Final Feasibility Report and Final Environmental Impact Statement/ Final Environmental Impact Report

February 1992

Sacramento Metropolitan Area California

US Army Corps of Engineers Sacramento District South Pacific Division

Modify Levees Around West Sacramento.

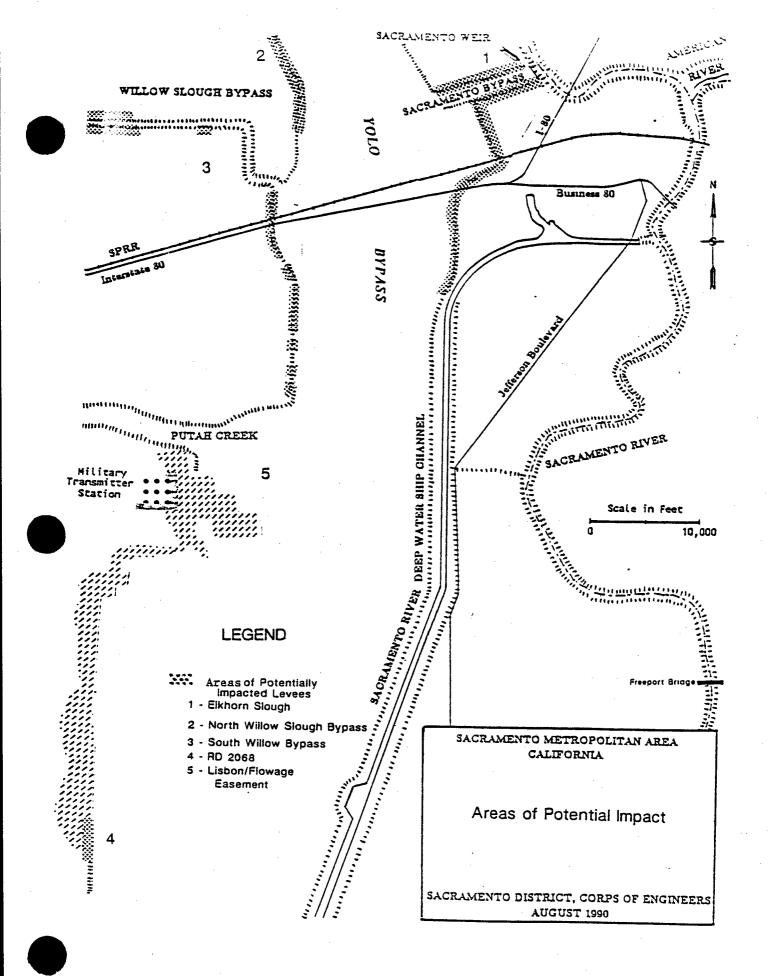
<u>Page 54, Figure 6.</u> Explanation of hatch mark symbols used in this figure is needed.

Page 54, Figure 6. Revised text. Corrected Figure 6 page 54.

Page 56, paragraph 2. Text has been corrected. Figure 6 on page
